ADDENDUM NO. 1

**JACKSON ELEMENTARY SCHOOL RENOVATIONS
Valparaiso, IN 46304**

This Addendum consists of page ADD 1-1 and attached Addendum No. 1 from Gibraltar Design dated November 9, 2022 and consisting of 4 pages and 29 drawings.

Addendum One (AD.01) to the drawings and specifications prepared by Gibraltar Design for **Jackson Elementary School Renovations** for Duneland School Corporation, Chesterton, Indiana.

Wednesday, 11/9/2022 - 9:49 AM - LAST SAVED BY: CONELSON
Y:\21-143 DUNELAND SC - JACKSON ES ADDITIONS AND
RENOVATIONS\21-143 DRAWINGS\05 ARCH\A-802.DWG

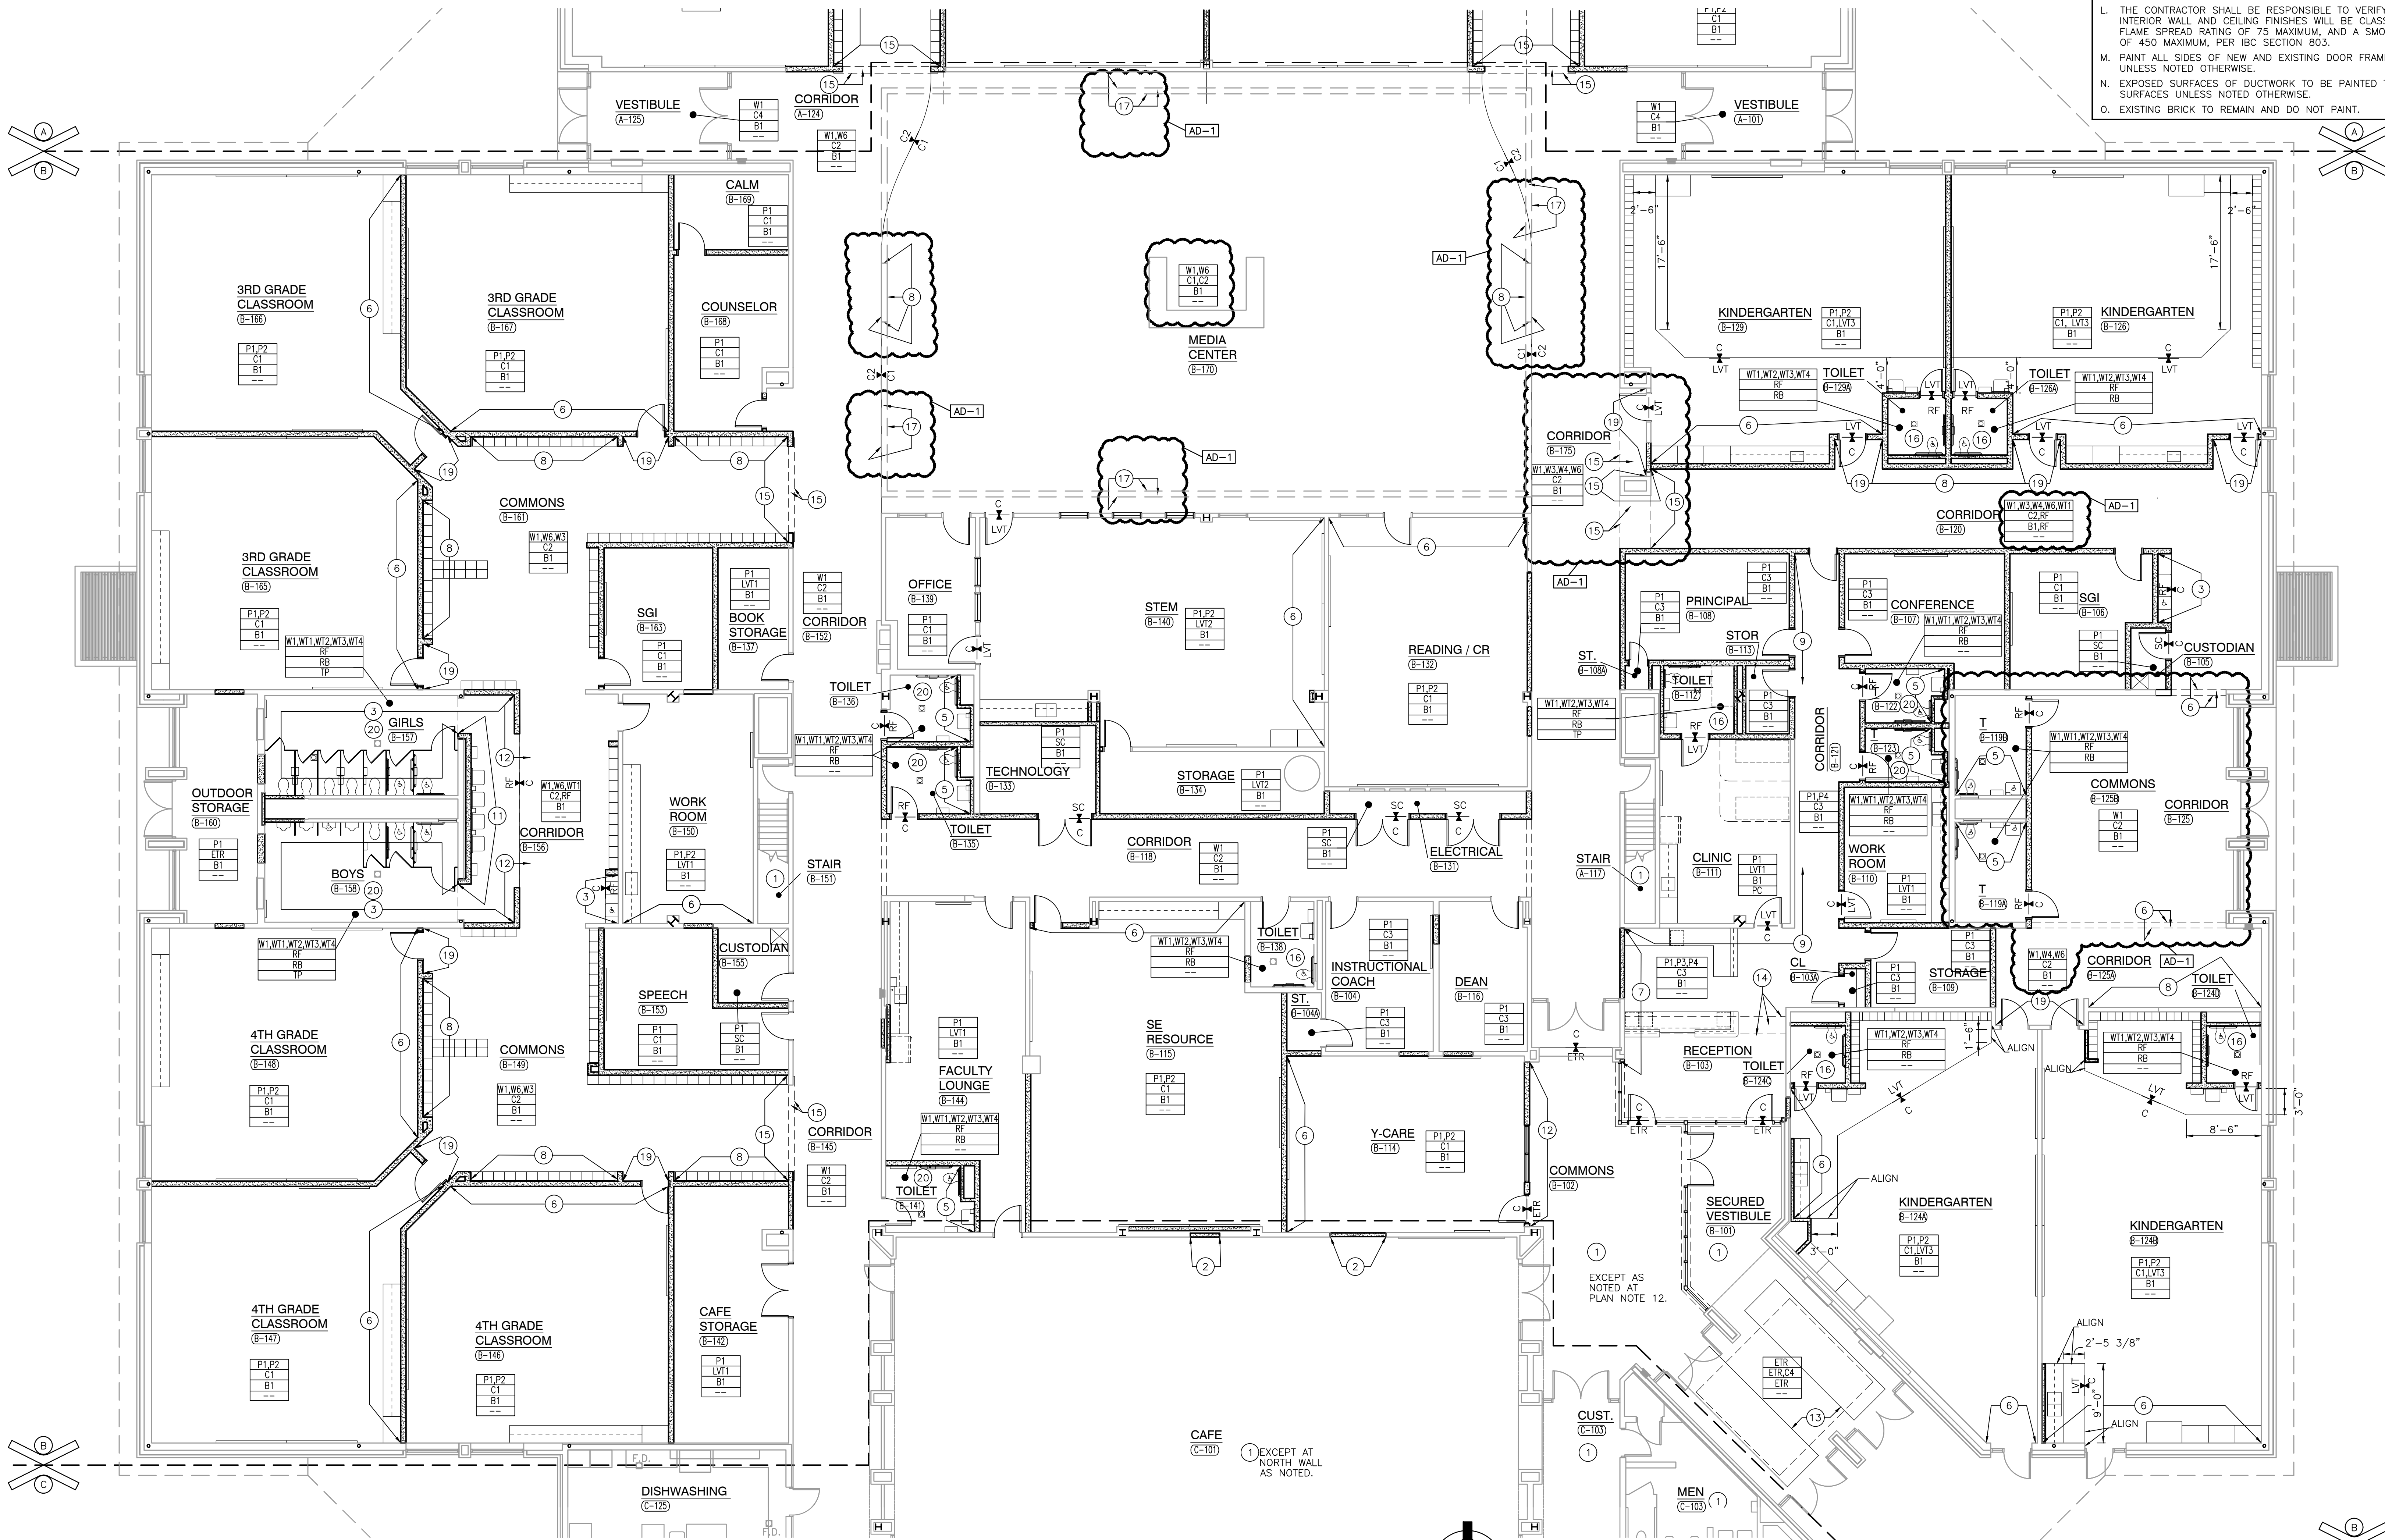
9. Sheets A-802 and A-803

A. Refer to two (2) revised full size drawings, included in this Addendum, for the following revisions:

1. Note plan finish changes.

MD101

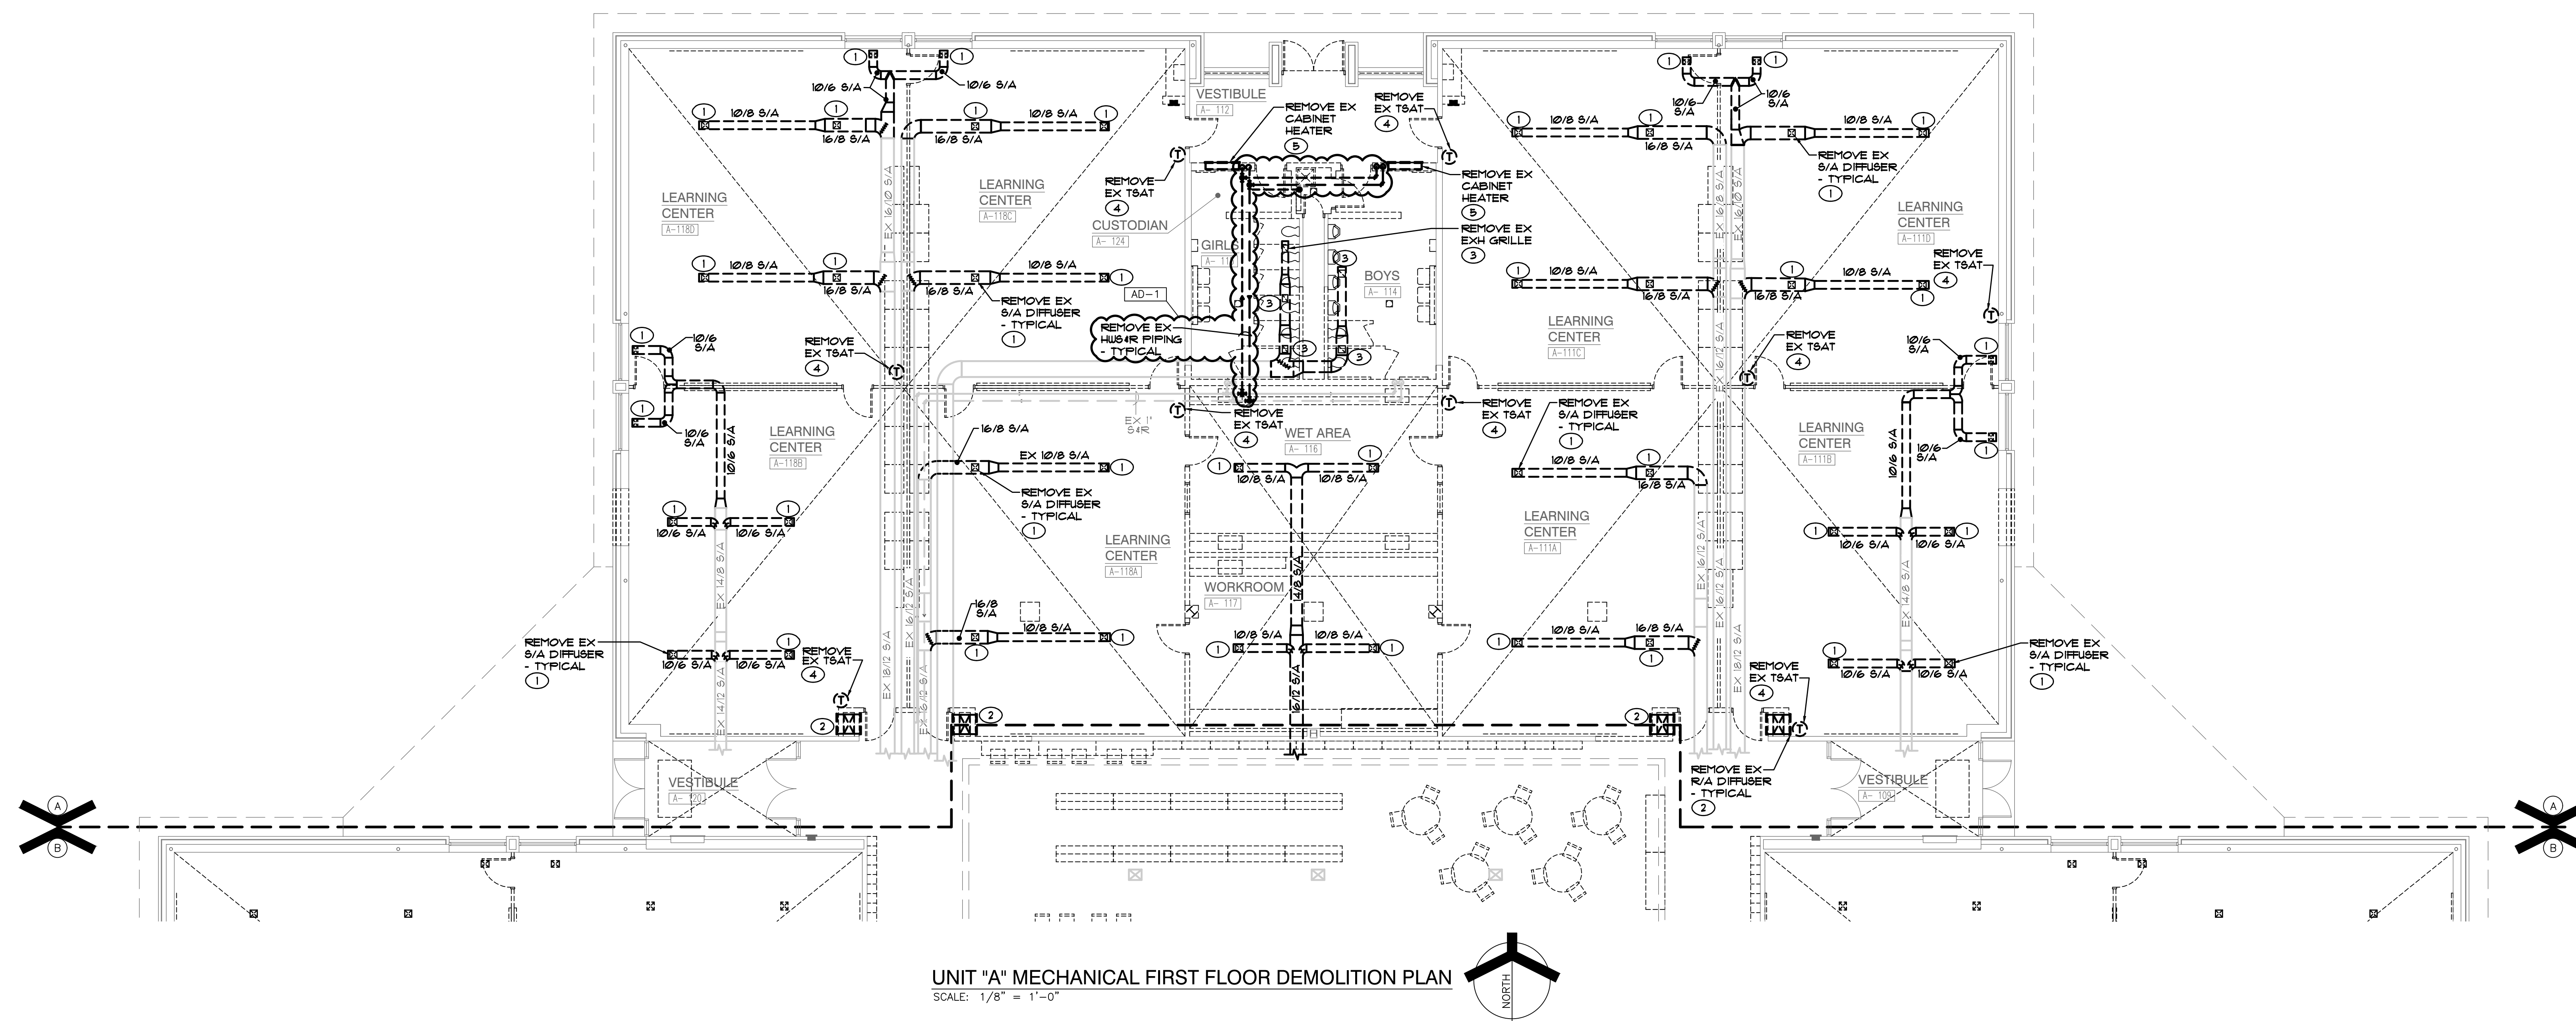
14. Sheet MD101

- A. Refer to revised full size drawing, included in this Addendum, for the following revisions:
 1. Revised existing hot water supply and return piping to demo.

© GIBRALTAR DESIGN SHEET
B MV102

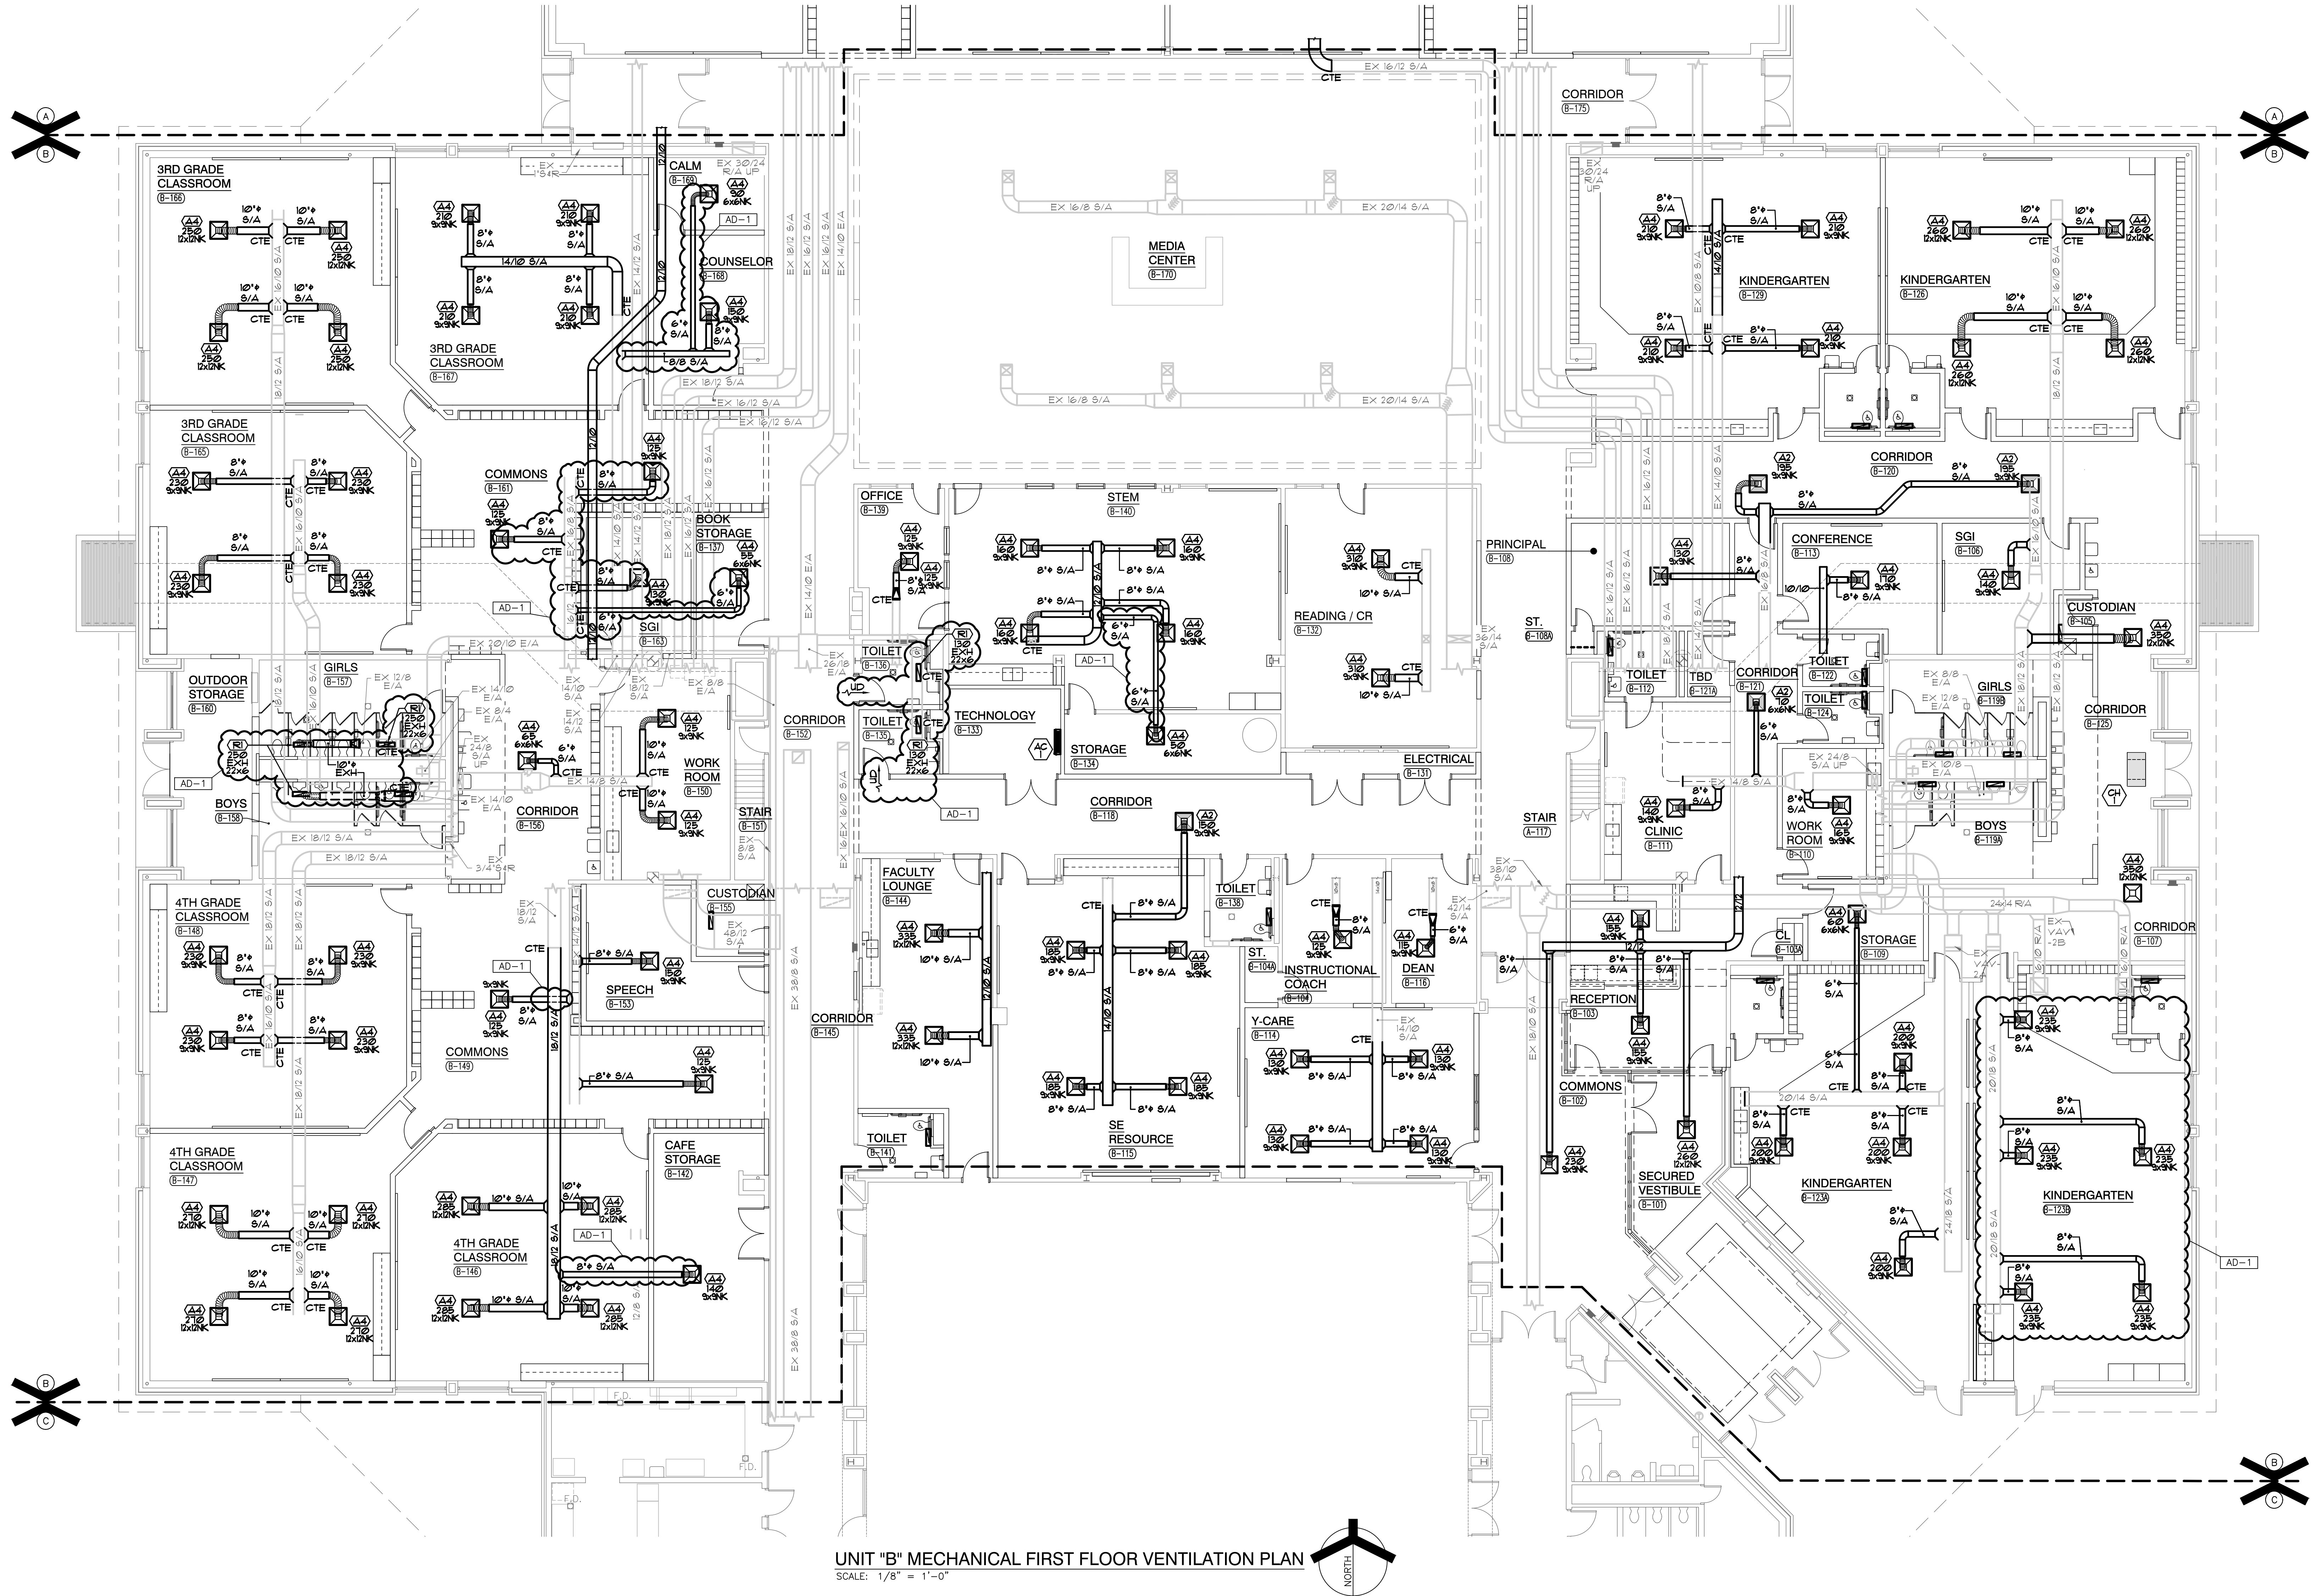
17. Sheet MV102

- A. Refer to revised full size drawing, included in this Addendum, for the following revisions:
 1. Revised duct take-off in Commons B-147
 2. Added ductwork to diffuser in Café Storge B-142, Commons B-161, SGI B-163, Counselor B-168, Calm B-169, and Storage B-134.
 3. Added exhaust to Girls B-157, Boys B-158, Toilet B-135, and Toilet B-136.
